Re: Request to Alter Injection Pattern
Cone Jalmat Yates Pool Unit No. 130
API No. 30-025-38918
610' FSL & 2015' FWL (Unit N) Section 13, T-22 South, R-35 East, NMPM,
Lea County, New Mexico

Melrose Operating Company
Form C-108; 10-Wells CJYPU
Injection Pattern Detail Map

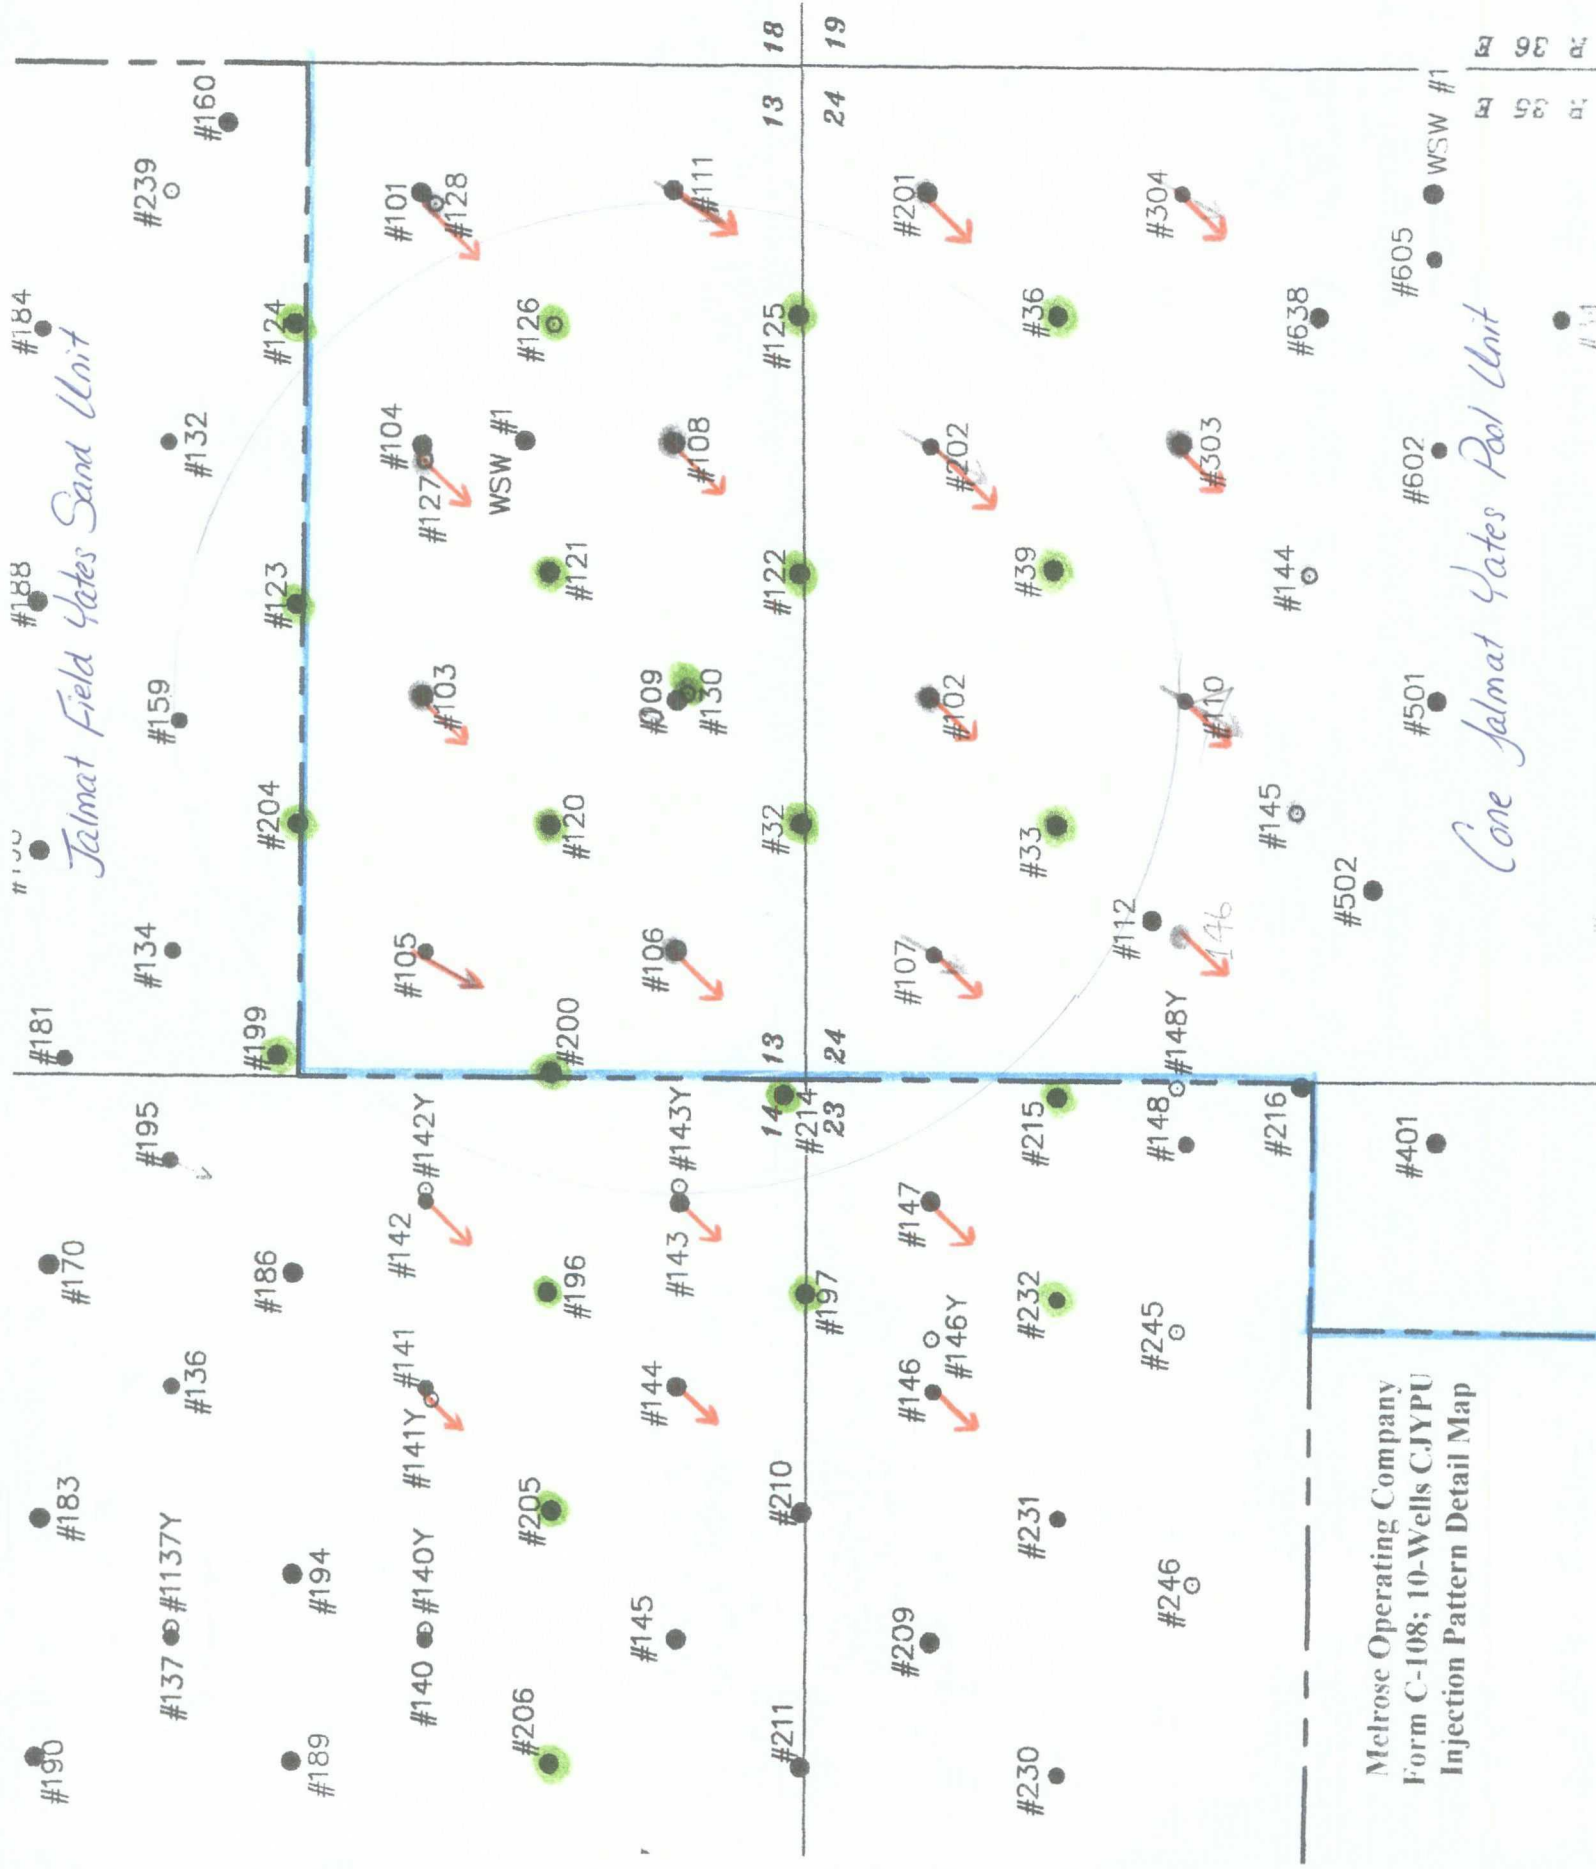
- (a) to change the injection pattern within the CJYPU Waterflood Project, thereby allowing Melrose to utilize the CJYPU No. 130 as a producing well instead of an injection well;
- (b) to plug the CJYPU No. 9 from a depth of 800' to the surface in accordance with a plugging program approved by the OCD Hobbs District Office;
- (c) to continue injection operations in the immediate area of the CJYPU No. 9; and,
- (d) to amend Division Orders No. WFX-852 and WFX-853 to relieve Melrose of any further stipulations that pertain to the CJYPU Well No. 9.

If the CJYPU No. 130 is shut-in for any reason in the future, Melrose will discontinue injection operations into any injection well located within 1/2 mile of that well until production operations resume.

Cone Jalmat Yates Pool Unit No. 009

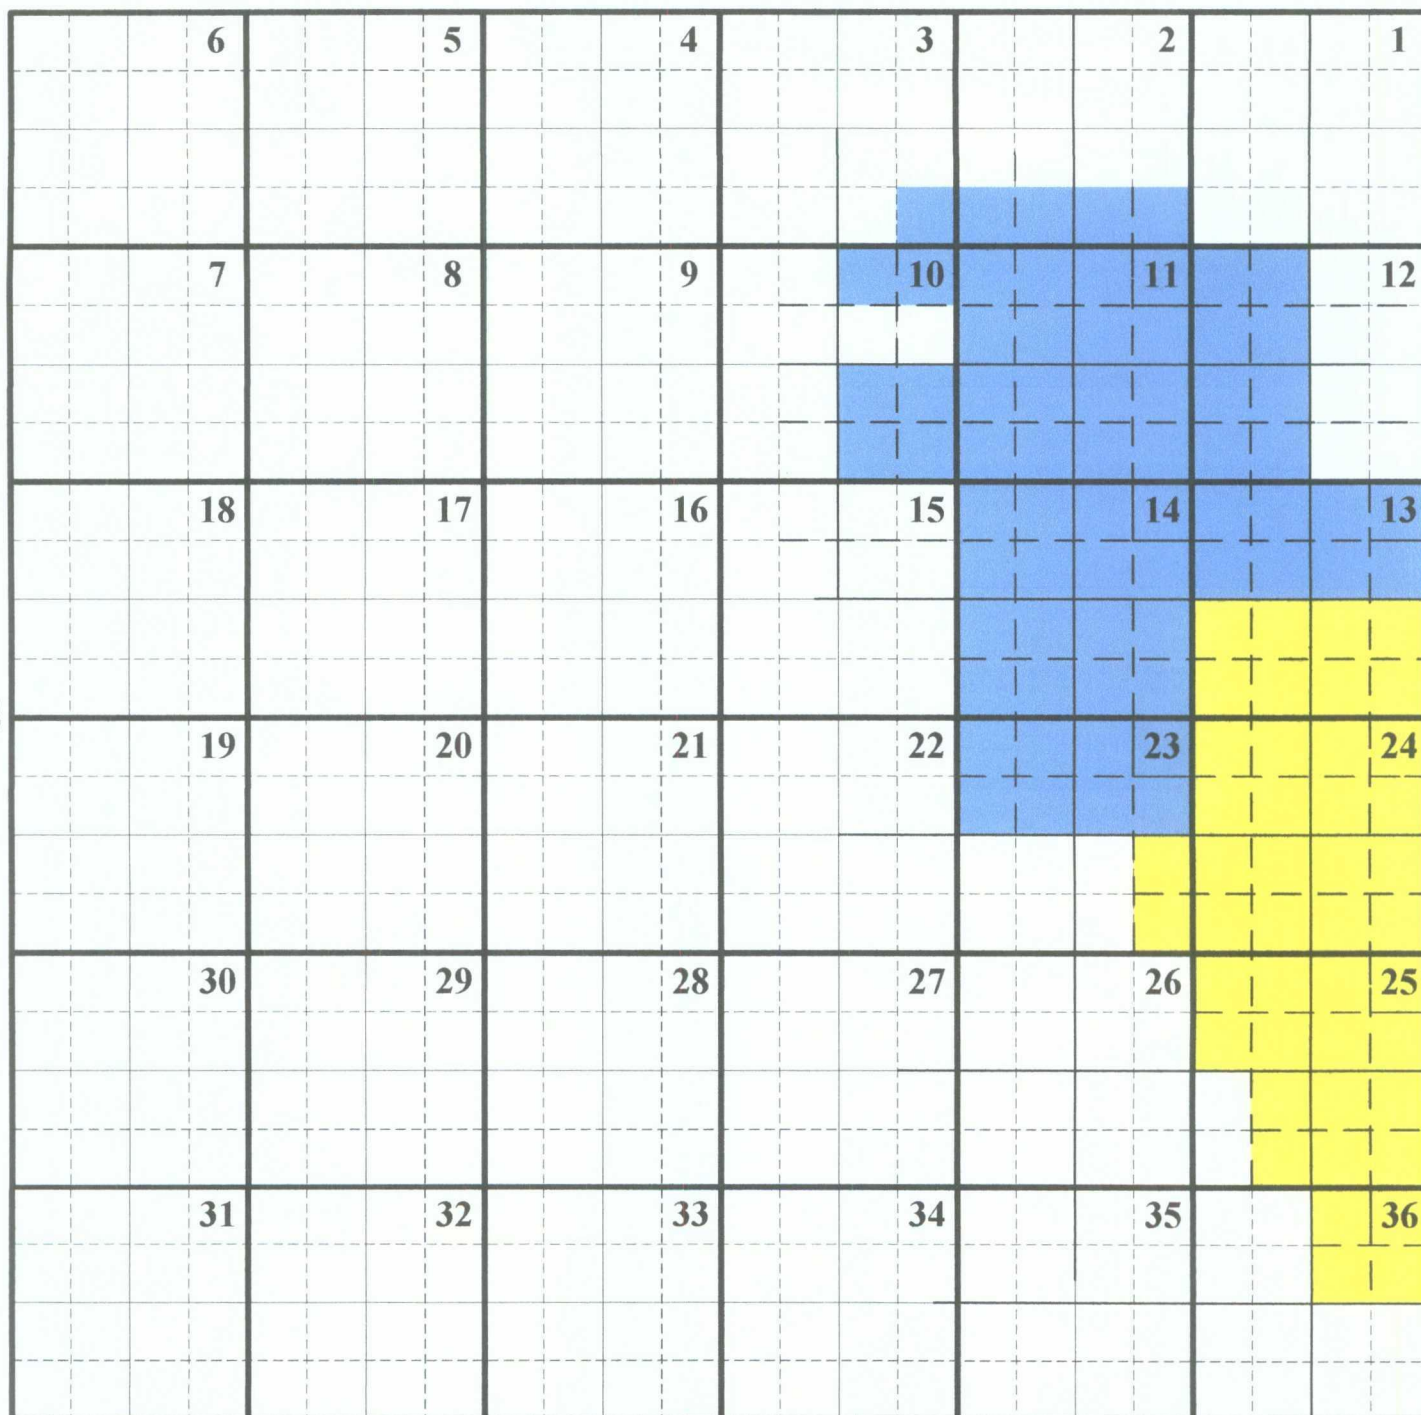
**10/87: Found casing leak @ 570'-635'.
Bradenhead squeezed w/200 Sx. Casing tested
okay. Resumed injection.**

**7/85: Found casing leak 927'-951'. Set retainer
@ 860' & squeeze cemented w/200 Sx. Casing
tested okay. Resumed injection.**

**Re-entered well May, 2009. Got down to a
depth of approximately 800'. Melrose will
plug the well from a depth of 800' to surface
in accordance with a Division approved
plugging program.**
